Date June 10, 2021
To Town of Cumberland Planning Board
From Carla Nixon, Town Planner
Subject **Final Plan Review: 13 Lot Major Subdivision –Blanchard Oaks**

Subject: Peer Review

**RE: Blanchard Oaks Subdivision,
365 Blanchard Road – Schooner Ventures III, LLC
Response to Final Plan Submission Peer Review Comments**

TYPICAL ROAD CROSS SECTION
NOT TO SCALE

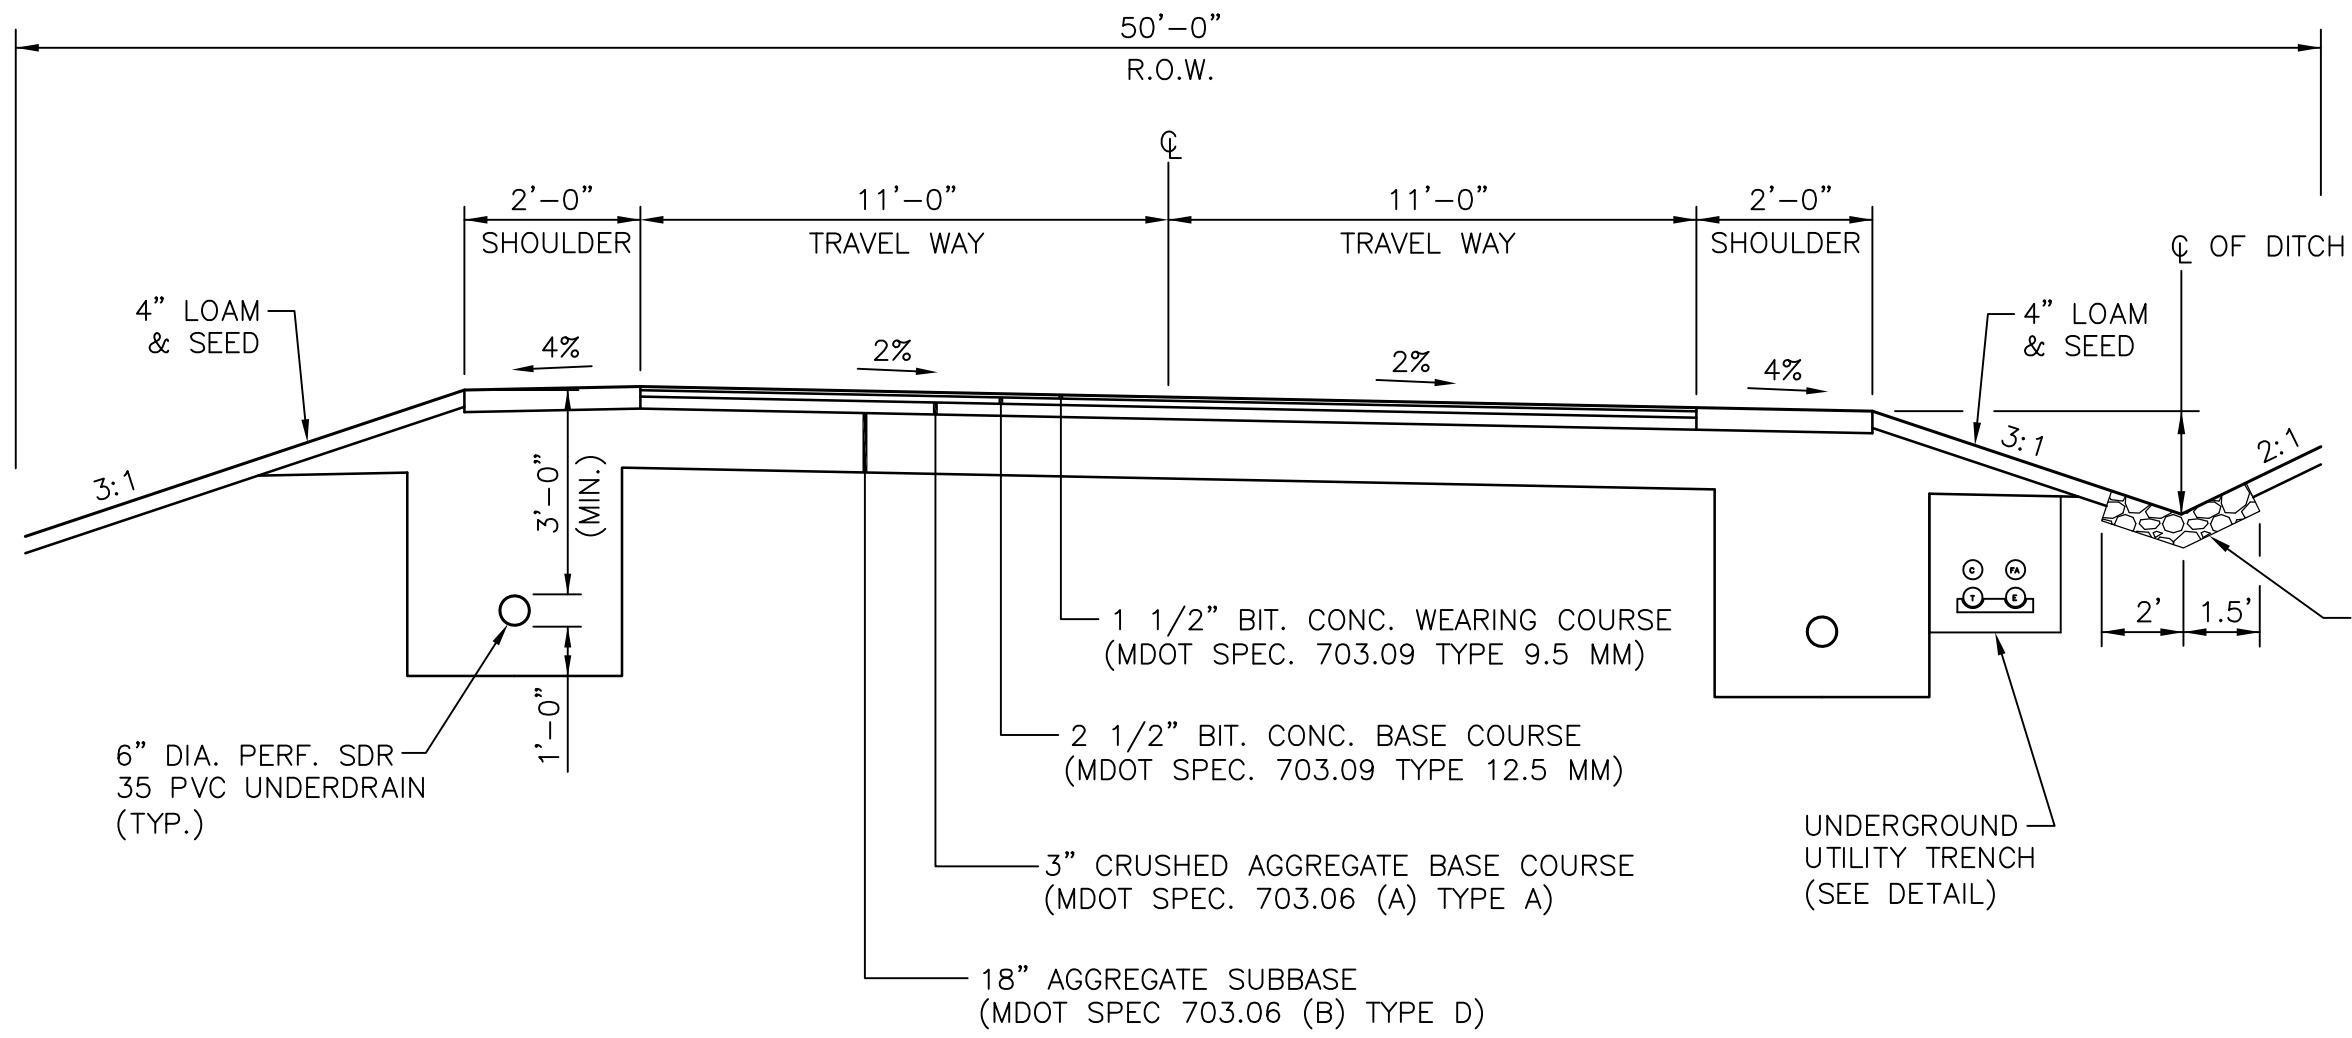
5. Has the impact to the wetlands from SD-8 construction adjacent to the cul-de-sac been included in the NRPA permit application?
6. Revise the rip rap detail on the typical road cross section to call out a rip-rap thickness of two times the D50 size in accordance with the Maine Erosion and Sediment Control Best Practices Manual for Designers and Engineers.

6. Revise the rip rap detail on the typical road cross section to call out a rip-rap thickness of two times the D50 size in accordance with the Maine Erosion and Sediment Control Best Practices Manual for Designers and Engineers.
The D50 size has been revised to 3"

TYPICAL ROAD CROSS SECTION
NOT TO SCALE

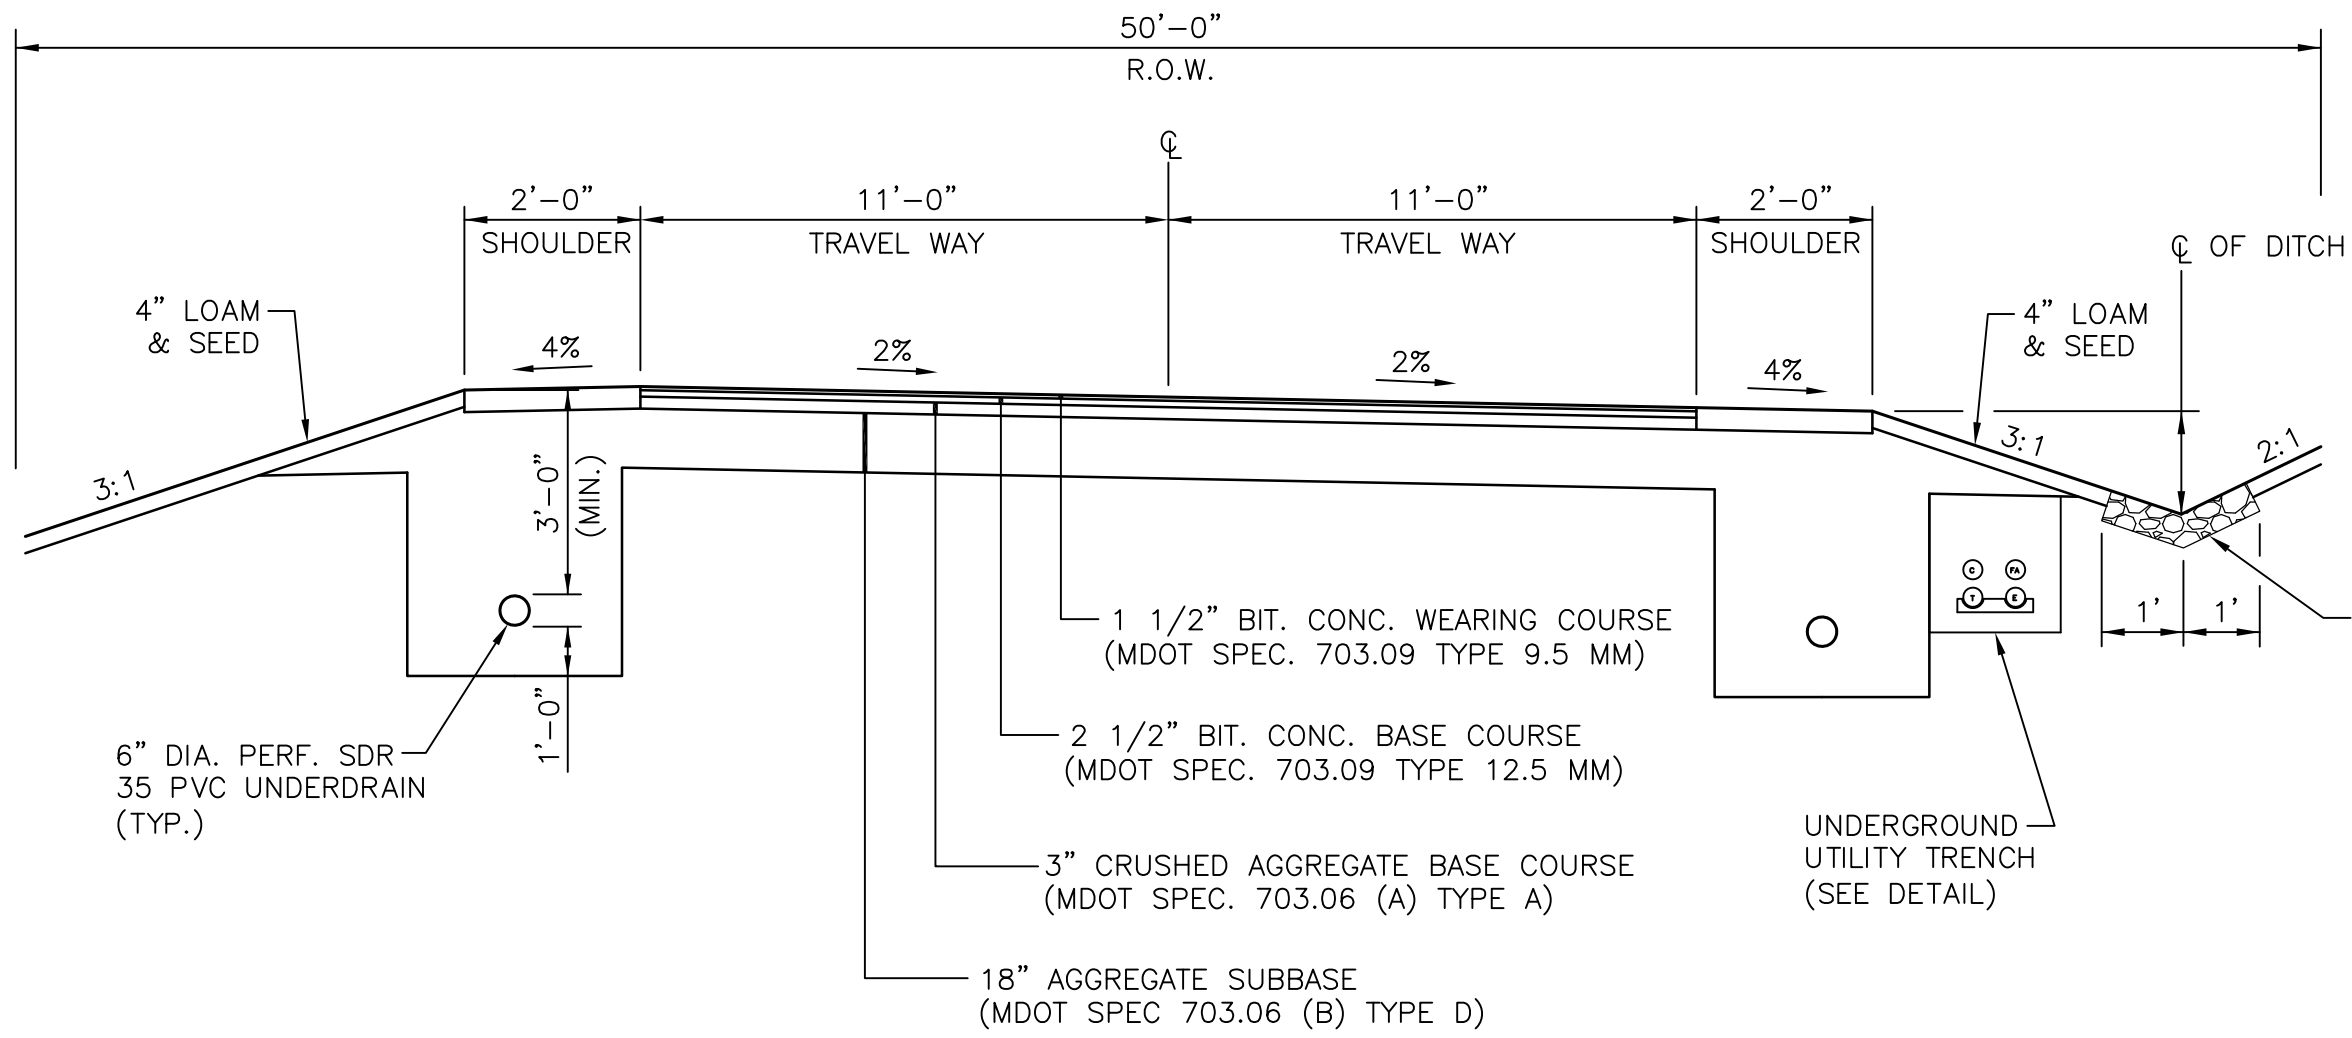
7. The 1' width of the rip rap section shown on the typical road section results in an approximately 4" depth of flow to the top of the rip rap at the 3:1 slope. What is the required flow depth in the ditches for the 10-year, and preferably the 25-year storm?
Utilizing a manning's number of 0.040 and a swale slope of 4.0% and using the largest contributing watershed, S20, the flow depth in a 10-year storm event will be 0.70 feet deep. The revised details show a total width of the riprap channel of 3.5 feet with a depth of 0.67'. Taking into consideration the void space in the riprap this will provide adequate scour protection for the swales within this project.
